Architect's Supplemental Instructions

Architect's Project No:
04561.01

Architect's ASI No: 025

See attached Exhibit A, and the above sheet list for rooms and locations of the point-of-use ANT, acid vent routing, piping diagrams, risers and acid vent through the roof locations.

2-1 SANITARY WASTE AND VENT RISER - VESTIBULE 183C AND LAB 191

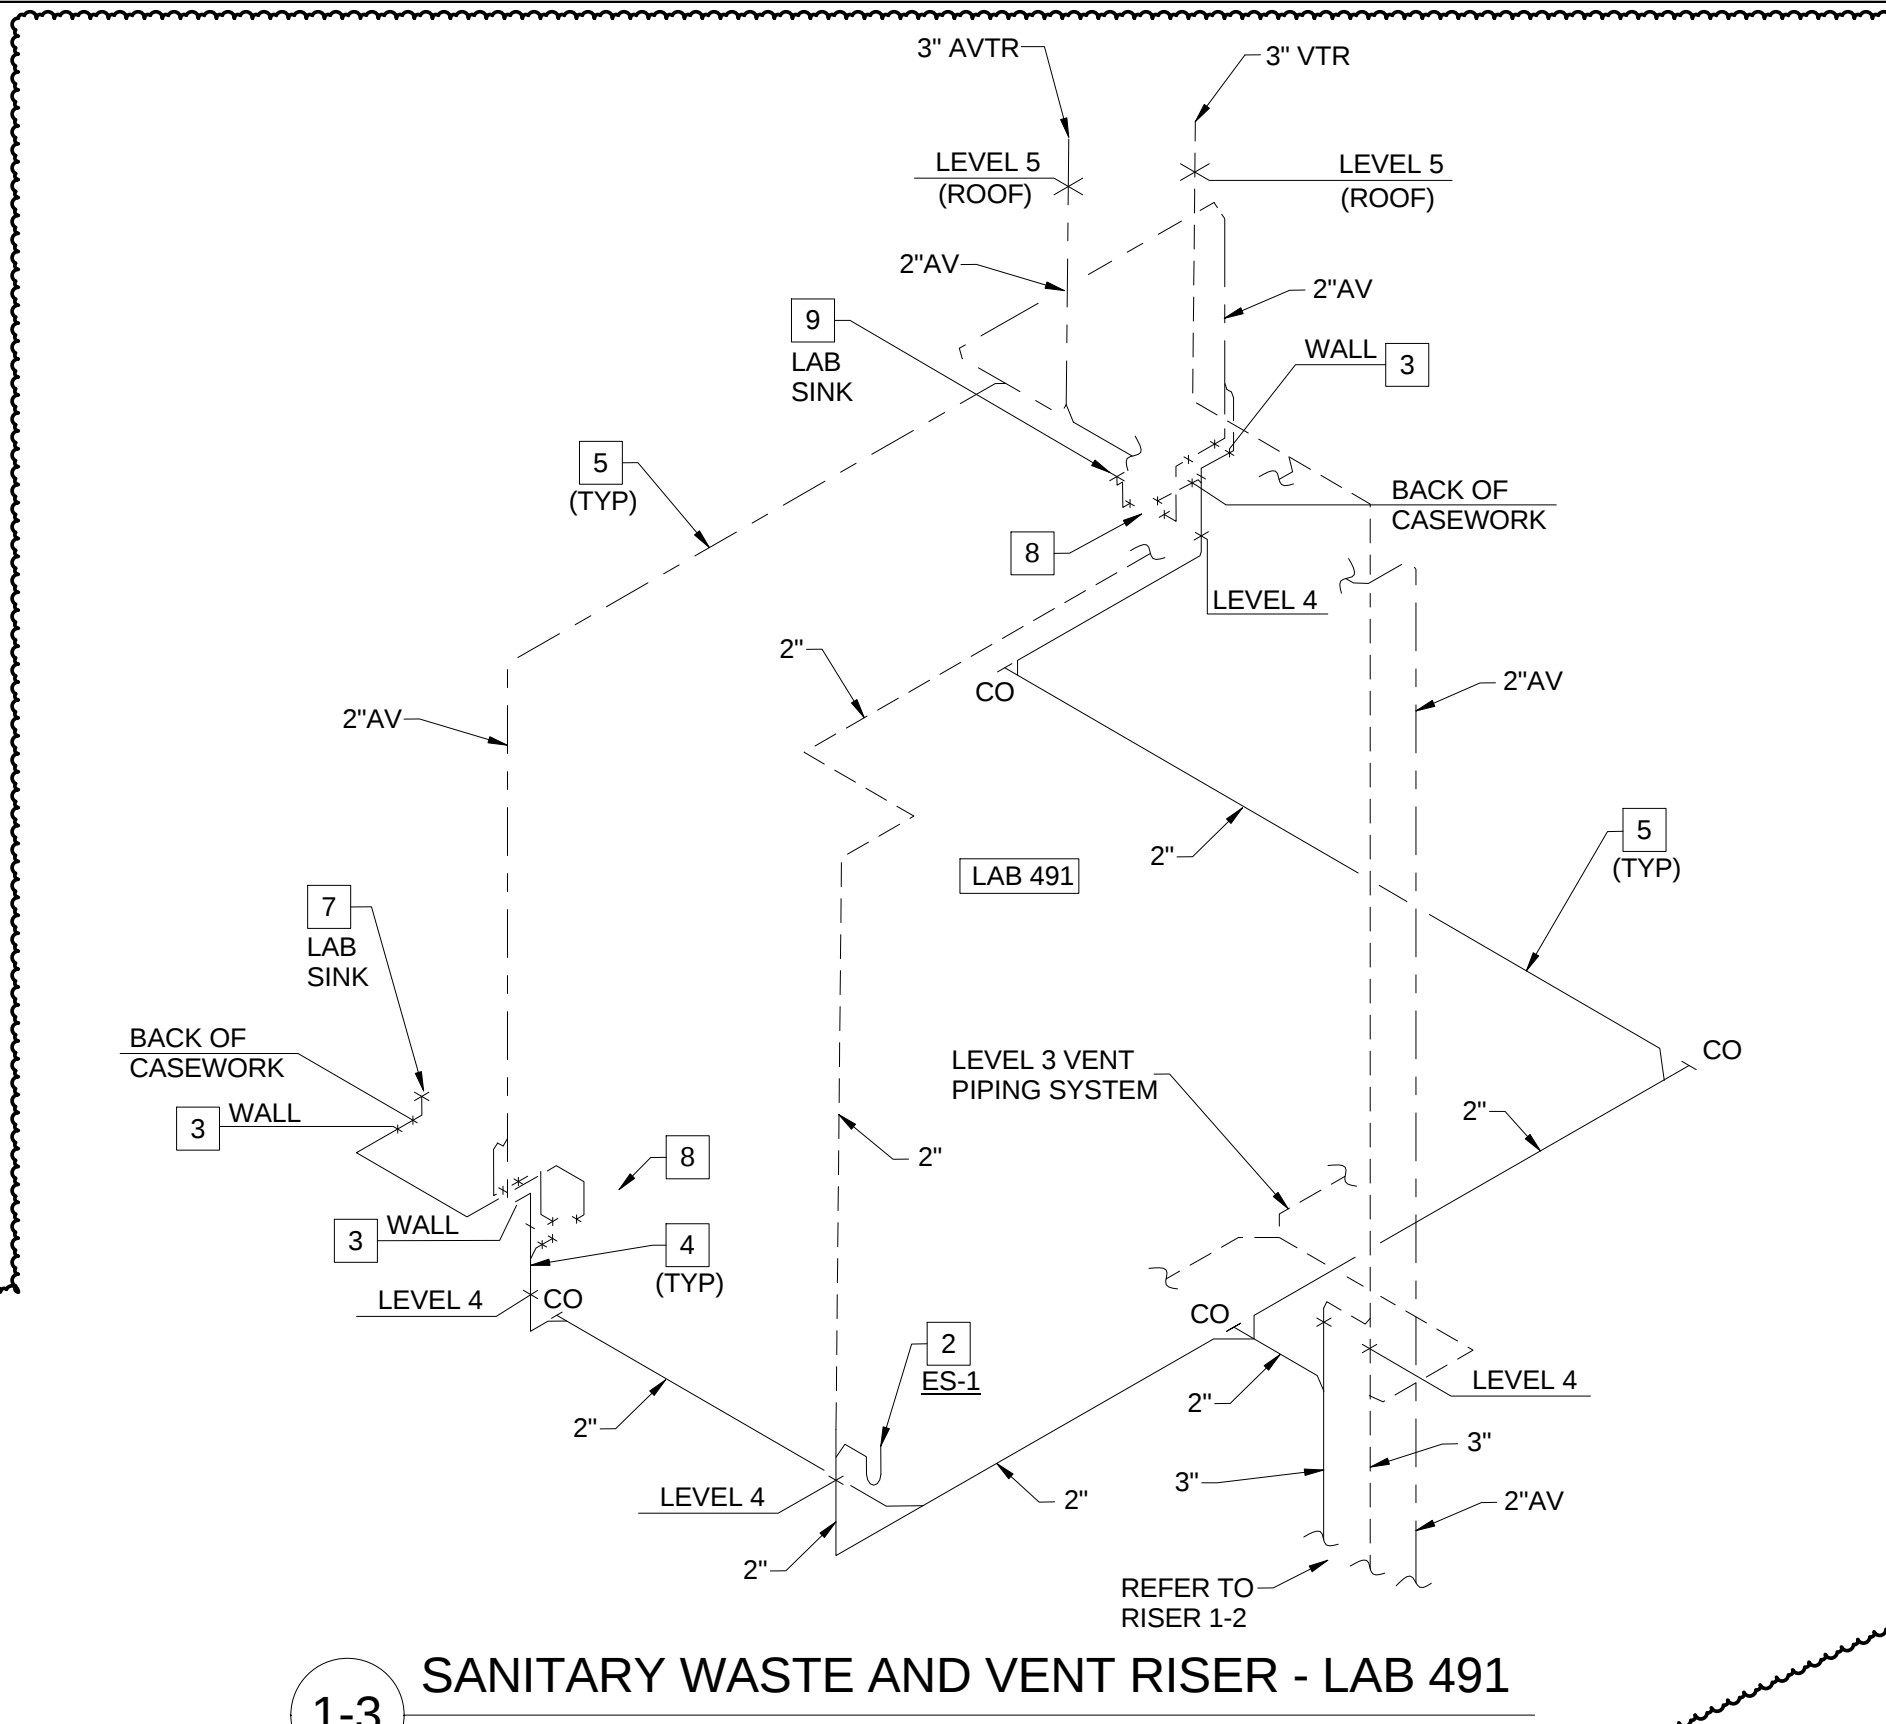
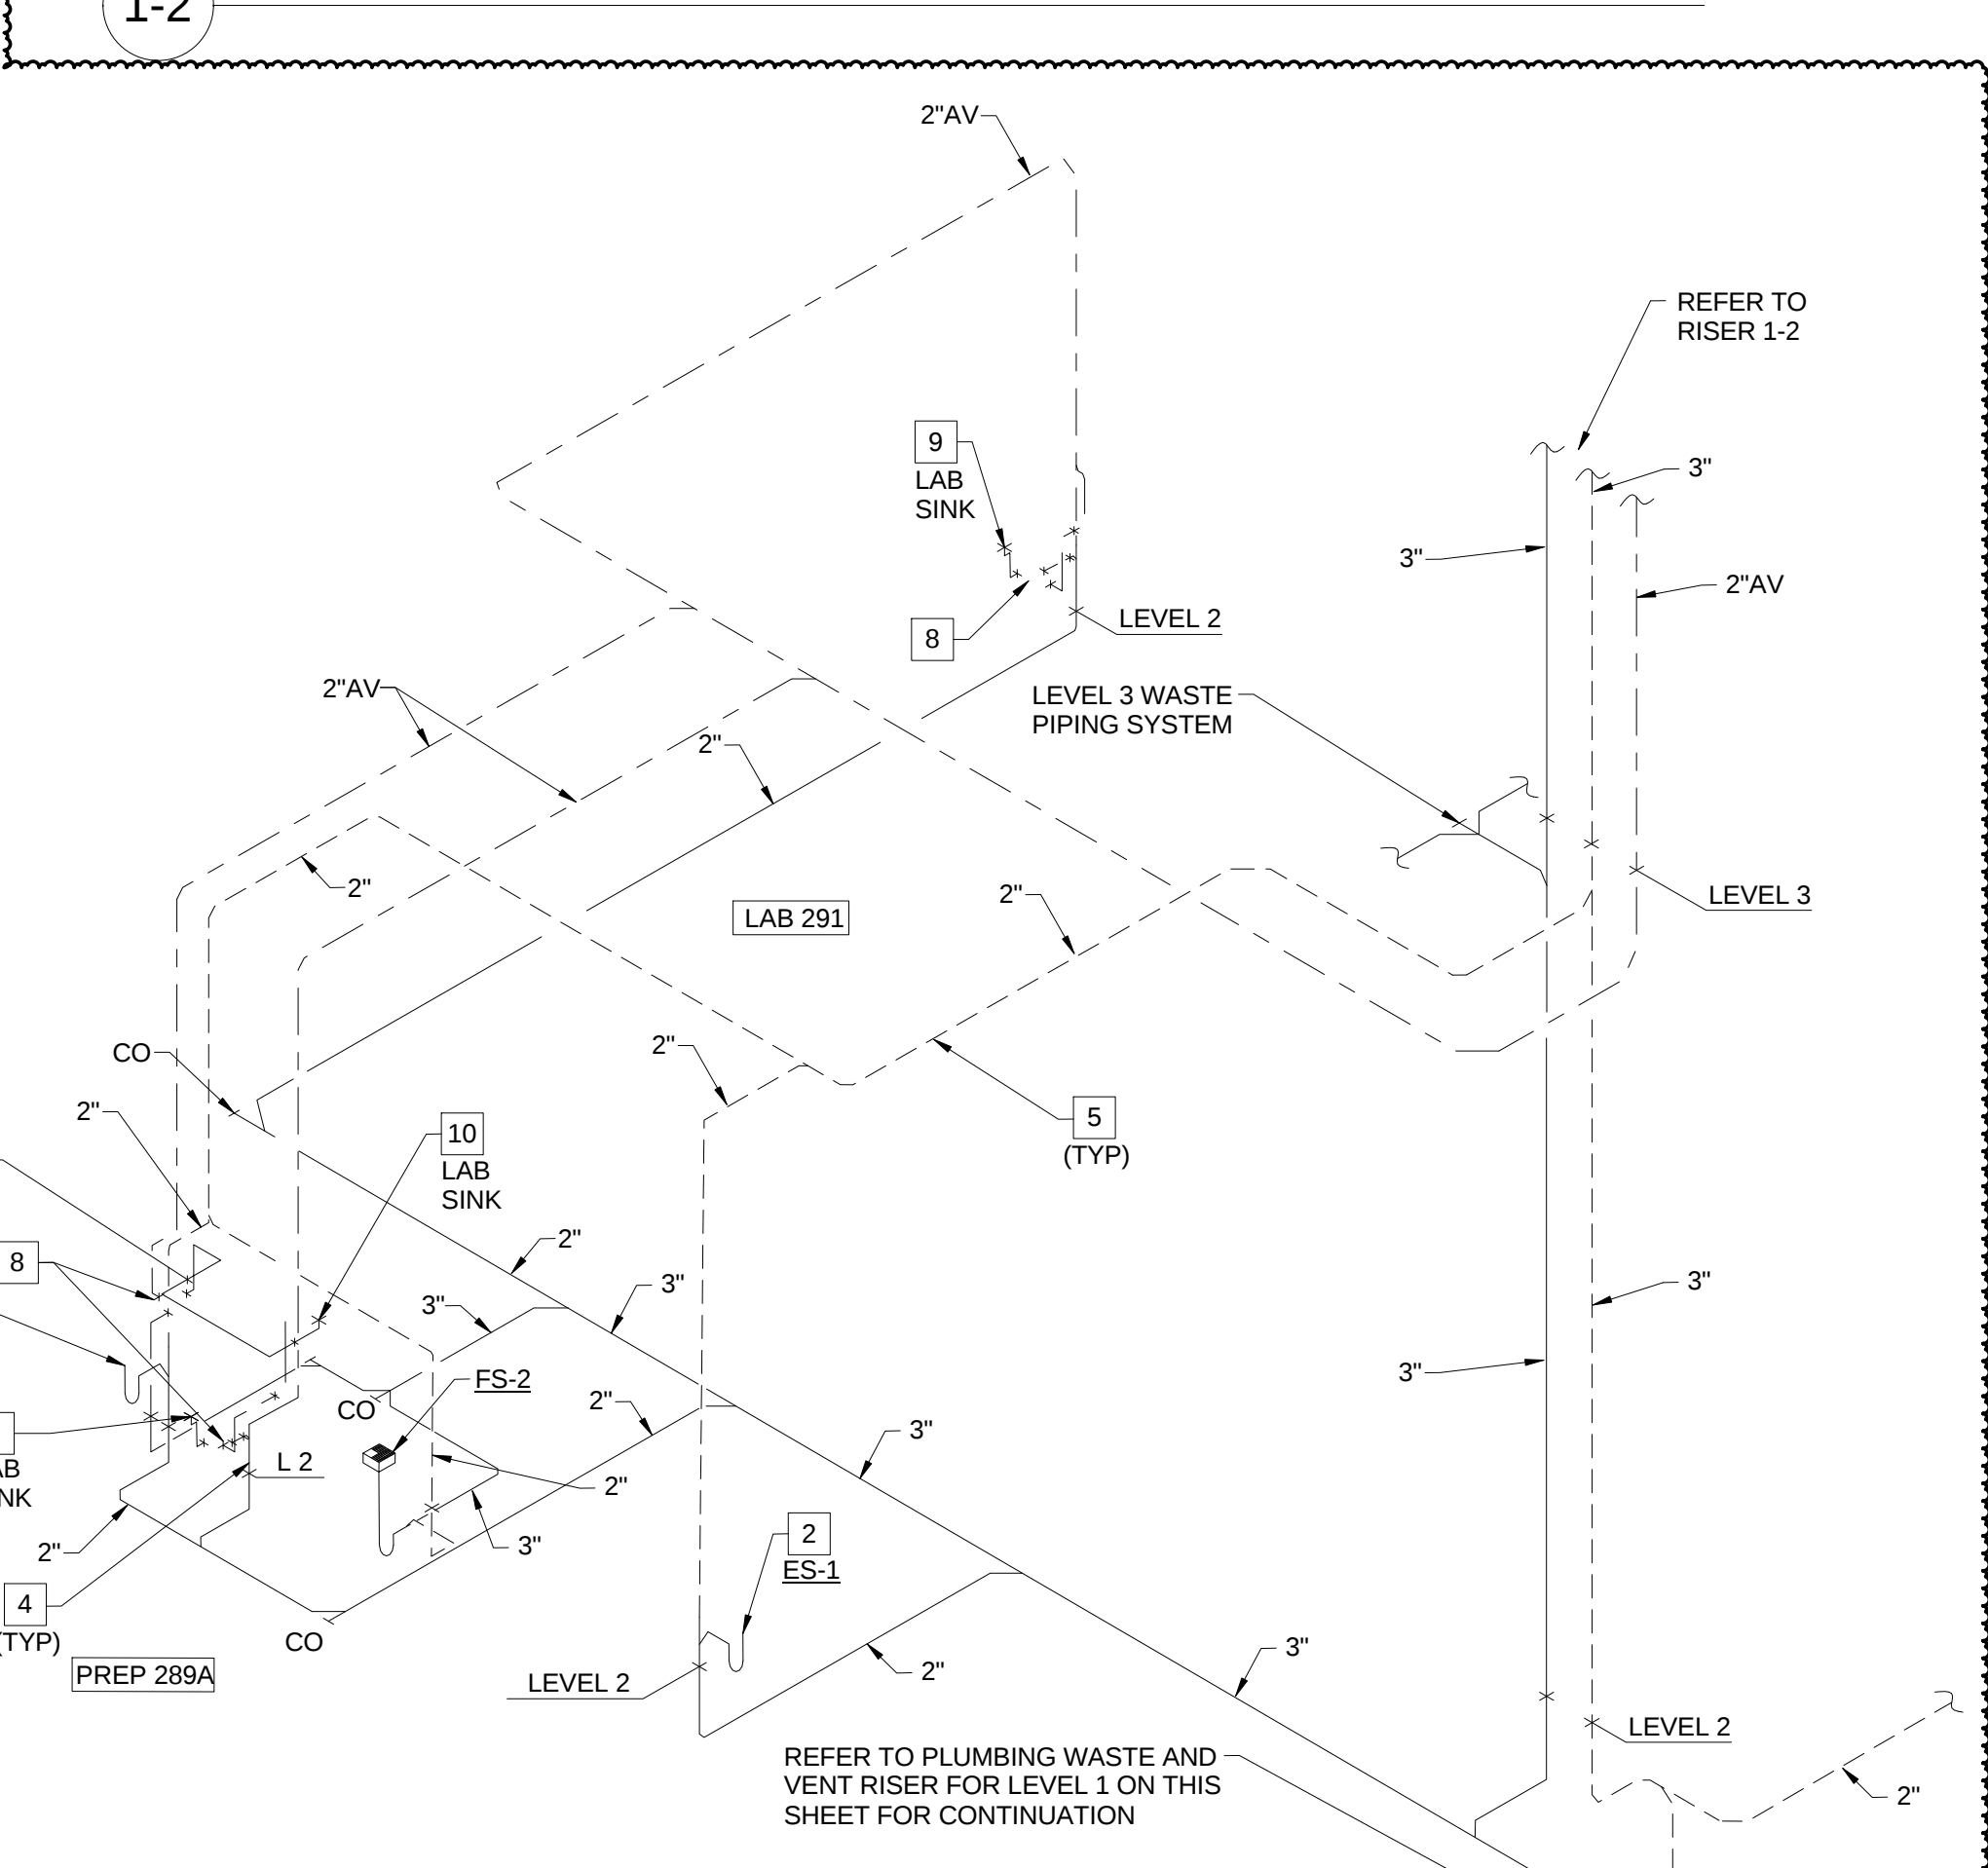
- 7 LAB SINK TO BE CONNECTED TO POINT-OF-USE NEUTRALIZATION TANK REMOTE FROM THE SINK LOCATION. COORDINATE WITH THE ARCHITECTURAL DRAWINGS FOR THE CASEWORK. REFER TO DRAWING P0404, DETAIL 1/P0404 FOR TYPICAL PIPING DIAGRAM. PIPING TO BE ADJUSTED AS REQUIRED FOR EACH LOCATION.

- 9 LAB SINK TO BE CONNECTED TO POINT-OF-USE NEUTRALIZATION TANK BELOW THE SINK. COORDINATE WITH THE ARCHITECTURAL DRAWINGS FOR THE CASEWORK. REFER TO DRAWING P0404, DETAIL 2/P0404 FOR TYPICAL PIPING DIAGRAM. PIPING TO BE ADJUSTED AS REQUIRED FOR EACH LOCATION.

- 10 LAB SINK AND GLASS WASHER TO BE CONNECTED TO POINT-OF-USE NEUTRALIZATION TANK REMOTE FROM THE SINK LOCATION. COORDINATE WITH THE ARCHITECTURAL DRAWINGS FOR THE CASEWORK. REFER TO DRAWING P0404, DETAIL 1/P0404 FOR TYPICAL PIPING DIAGRAM. PIPING TO BE ADJUSTED AS REQUIRED FOR EACH LOCATION.
